**Environmental Impact Statement (EIS)
assessment report under the
*Environmental Protection Act 1994***

Drake Coal Project proposed by Drake Coal Pty Ltd
(A wholly owned subsidiary of QCoal Pty Ltd)

Prepared by: Statewide Environmental Assessments, Department of Environment and Heritage Protection

September 2013

Figure 2 - Cross-section of levee buttress proposal around West Pit 1 final void (Source: Drake Coal Project - EM Plan)

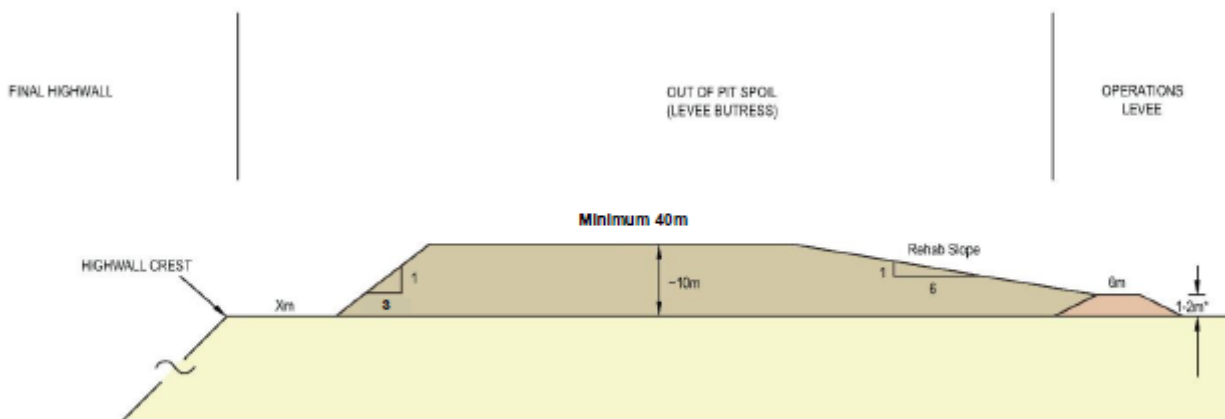
EHP, the Mackay Conservation Group and one public submission commented on the EIS that the 1-in-1000-year levees proposed to protect West Pit 1 and East Pit 4 during operations would be insufficient to protect these voids from overtopping in the longer term after mining had been completed. EHP requested the proponent to revise the mine closure plan. The proponent provided further information in the SEIS and in additional correspondence received on 8 July 2013. As identified in section 2 of this report, the proponent has committed to completely backfilling the East Pit 4 void, removing the need for a levee after mining has been completed. The proponent also committed to reducing the final footprint of the West Pit 1 final void and ensuring that the void would be protected from floodwaters above the probable maximum flood (PMF) level. The commitments for the rehabilitation of West Pit 1 include:

- completely backfilling the northern void
- reducing the volume of the southern void
- construct a 10m high spoil buttress behind the operational levee to provide flood protection for the void above the PMF level (see Figure 2).

EHP considered the proposal and determined that it provided adequate flood protection for the West Pit 1 final void. A condition about the decommissioning of final voids with flood protection above the PMF level would be included in the project EA (Appendix 2).
